April 12, 2019

Honorable Mayor, Members of the City Council, and Members of the Planning Commission
211 Hillcrest Avenue
Marina, CA 93933
Attn: Christy Hopper, Planning Services Manager and Deborah Mall, Deputy City Attorney
chopper@cityofmarina.org; planning@cityofmarina.org; attys@wellingtonlaw.com

SUBJECT: HWG COMMENTS ON REMY MOOSE MANLEY LETTER ATTACHMENTS PREPARED BY HGC, EKI, AND AGF FOR CITY OF MARINA PLANNING COMMISSION HEARING AGENDA ITEM #6A ON MPWSP COASTAL DEVELOPMENT PERMIT HELD ON FEBRUARY 14, 2019

COMPARISON OF AEM PROFILE WITH FIELD/LAB BASED CHLORIDE CONCENTRATIONS

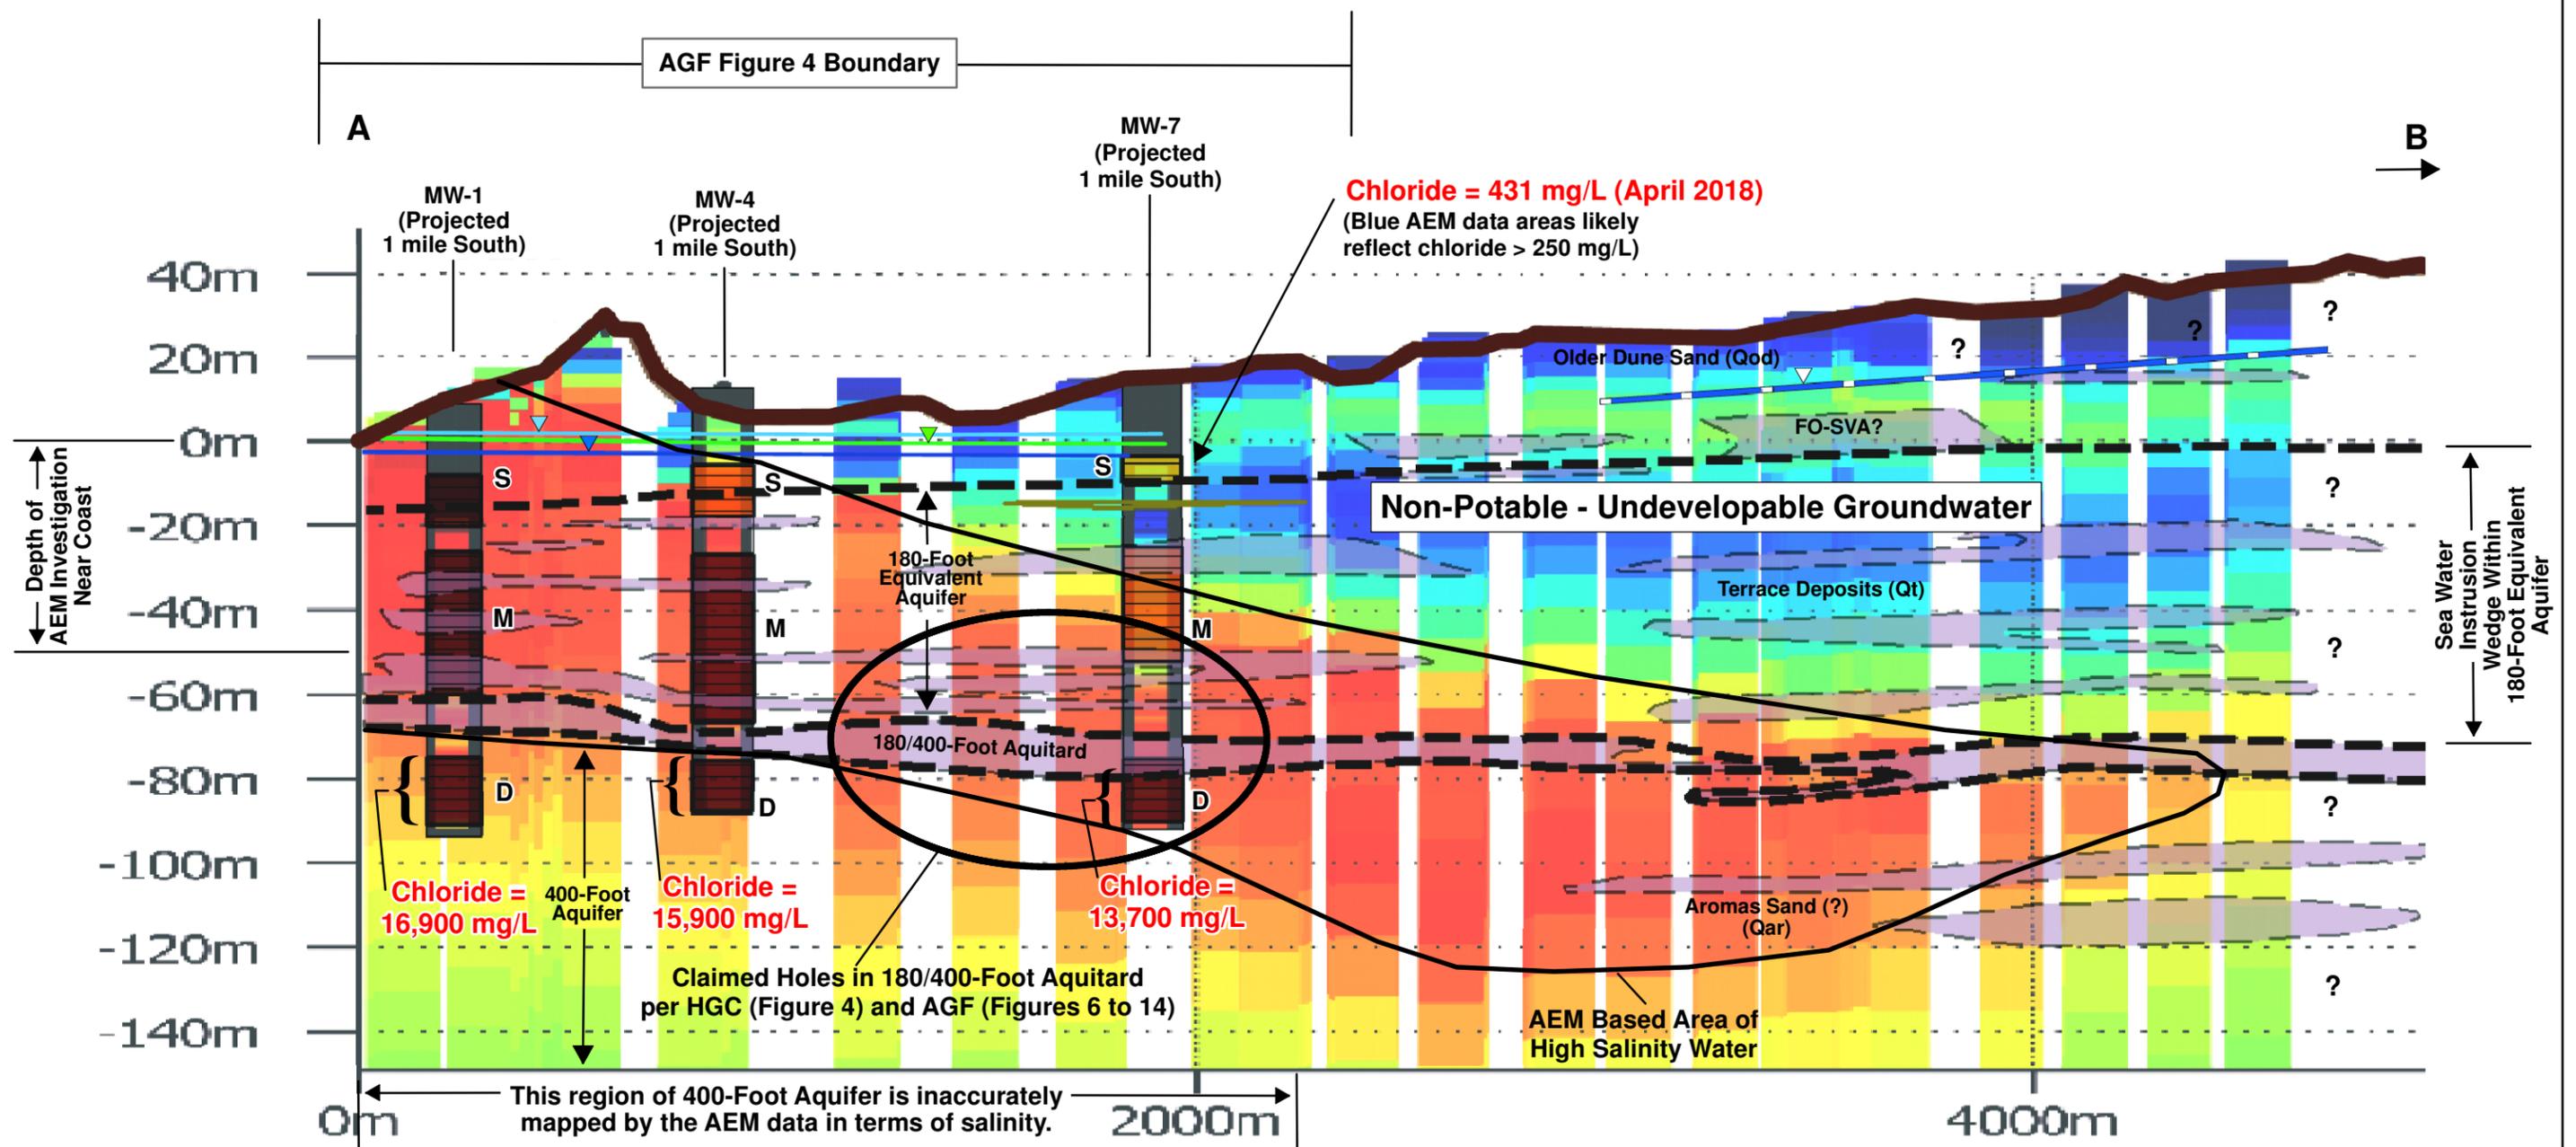
2. Top portion of Figure 4. HGC shows an arrow pointing downward across the 180/400-Foot Aquitard in the vicinity of MW-7. (Page 13).

HWG Response: *There are a few important points to discuss here, some of which are illustrated on the attached **Figure 1**. First is that the depth of investigation (DOI) near the coast was limited and did not extend to or through the 180/400-Foot Aquitard or into the underlying 400-Foot Aquifer (see page 13 and Figures 4 and 5 from Final AEM Report). Therefore, the inverted apparent bulk resistivity shown for 180/400-Foot Aquitard and 400-Foot Aquifer west of MW-7 (to the left of MW-7 on the figure) is unknown and should not even be shown on this profile (i.e., the AEM imaging of the 400-Foot Aquifer west of MW-7 is invalid). Second, we note that even attempts to extend apparent inverted bulk resistivity below the DOI in MW-1 and MW-4 (Figures 4 and 5 of Final AEM Report) do not match particularly well with the lower borehole resistivity (implying higher salinity, although not accounting for lithology) in the top of the 400-Foot Aquifer. Third, there is no calibration of AEM data to the 400-Foot Aquifer in this area even where MPWSP borehole data and well data are available. This is due to a combination of the limited DOI west of MW-7 and the fact that MPWSP borehole well data only penetrate the upper 50 feet of the 400-Foot Aquifer throughout the area. Finally, review of field/lab based TDS/chloride concentrations in the upper portion of the 400-Foot Aquifer (MW-1D, MW-3D, MW-4D, MW-7D) show highest salinity at the coast and gradually decreasing salinity inland (from about 31,000 mg/L TDS and 17,000 mg/L chloride at the coast to about 27,700 mg/L TDS and 13,700 mg/L chloride at MW-7D). These water quality data from MPWSP monitoring wells in the 400-Foot Aquifer stand in direct opposition to interpreted AEM data for the 400-Foot Aquifer (shown in HGC Figure 4), which shows lower salinity at the coast and increasing salinity inland to MW-7D and further inland (see attached **Figure 1**). From a practical perspective, this (AEM data interpretation) can't be correct because salinity would not be greater further inland and away from the coast when seawater is clearly entering the aquifer from the seabed. Thus, monitoring well data proves the inverted AEM data interpretation is flawed and invalid in the 400-Foot Aquifer where HGC shows a flow arrow crossing the 180/400-Foot Aquitard in Figure 4.*

HWG Response: *Figure 11 and the other associated figures described in item 3.F.7 are clearly inaccurate. This is demonstrated by review of available MPWSP monitoring well data in this area as summarized in the attached **Table 2**. These data show chloride concentrations ranging from approximately 17,000 mg/L at the coast to 14,000 mg/L about 6,000 feet inland within the upper portion of the 400-Ft Aquifer. These actual field/lab measured values far exceed the estimated chloride concentrations by AGF, which appear to range from about 3,000-5,000 mg/L near the coast (where actual values are about 17,000 mg/L) to about 7,000-10,000 mg/L at distances of 4,000 to 5,000 feet inland (where actual values are about 14,000 mg/L) of the coast. In the color-coding scheme used by AGF, the actual field-measured chloride values for AGF Figures 6 through 11 all fall well within the dark brown color band range (chloride 10,000 to 19,000 mg/L), yet all of these AGF figures show the 400-ft Aquifer within the much lower chloride concentration yellow color band with an AEM estimated chloride concentration of 3,000 to 10,000 mg/L. Clearly, actual field-based chloride data were not used to calibrate or constrain AGF’s analysis of AEM data, not even from the seven boreholes that are otherwise claimed to have been used for calibration of inverted AEM resistivity values.*

FIGURE 2

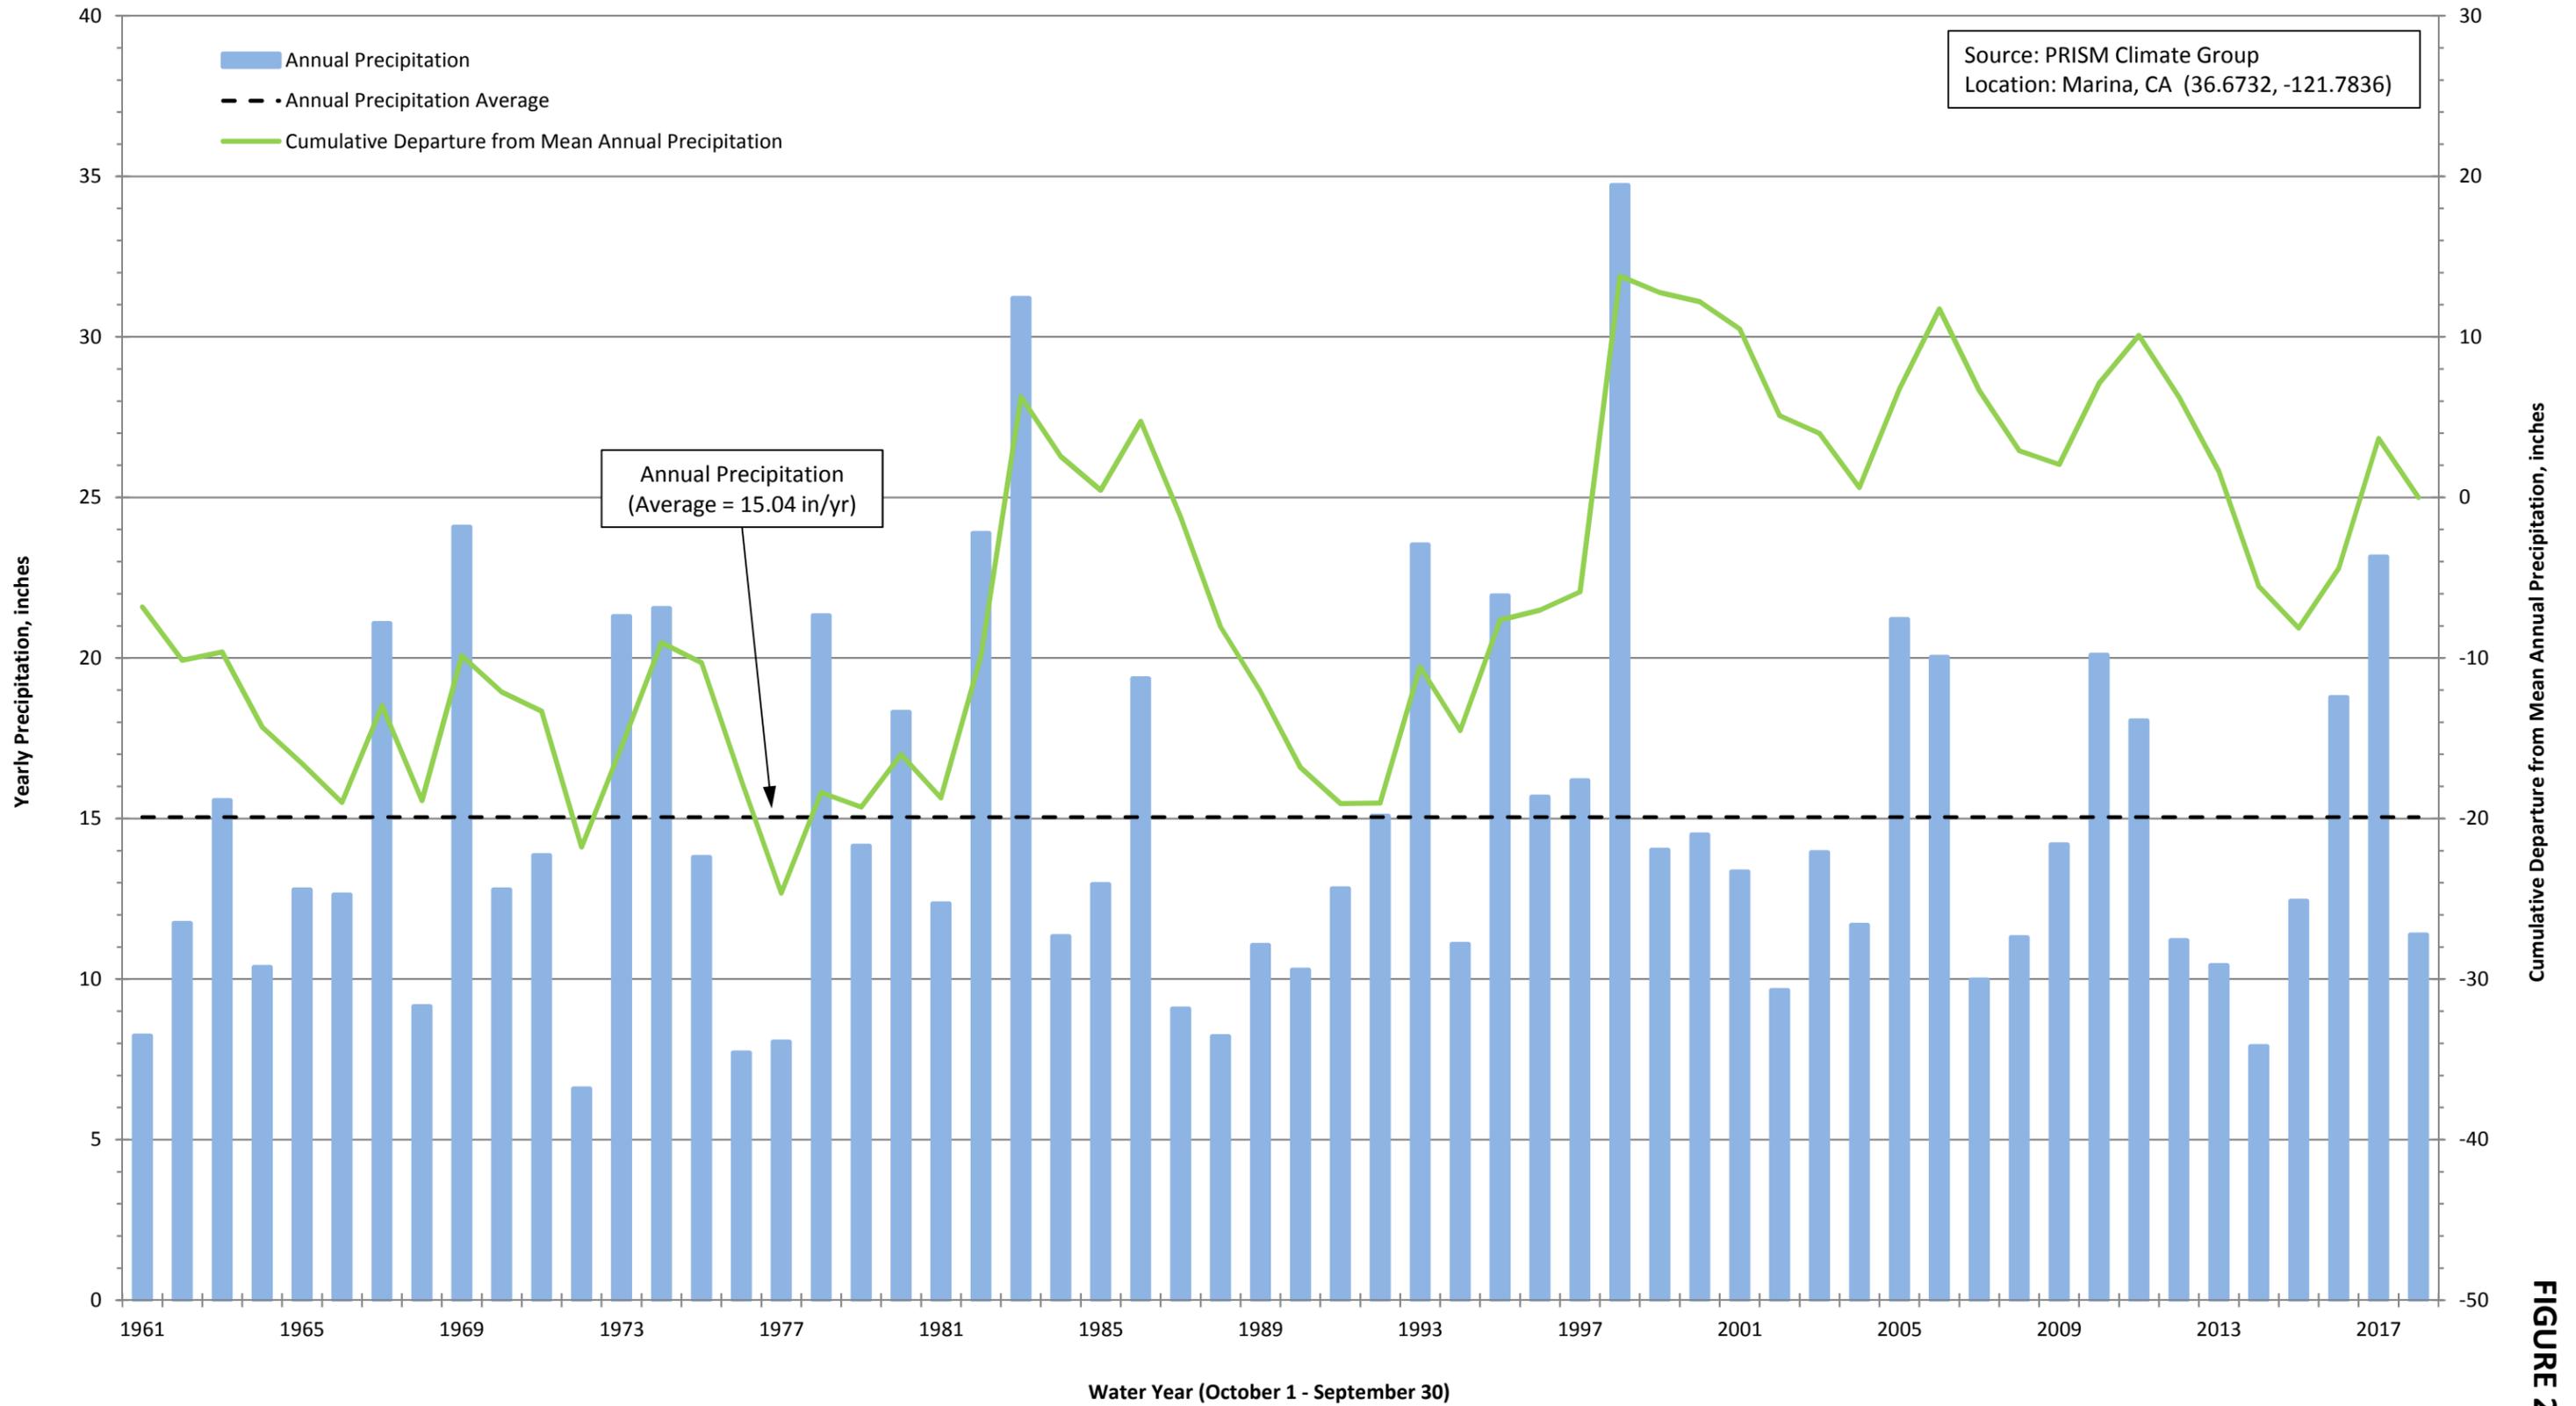
HWG Response: *There are six climate stations in the MPWSP vicinity for comparison to the station used by HGC, as summarized in **Table 1**. As is apparent from review of **Table 1**, HGC has cherry-picked the climate station with the least rainfall compared to normal during the 2015 to 2019 period. Review of all stations shows that the combination of water years 2015 and 2016 were slightly above normal and the combination of water years 2017 and 2018 were well above normal. Water year 2017 was clearly one of the wettest on record. Thus, various statements about 2018 water levels representing average conditions and previous years being drought conditions are inaccurate. In fact, the entire 2015 to 2018 period is cumulatively well above average for rainfall.*
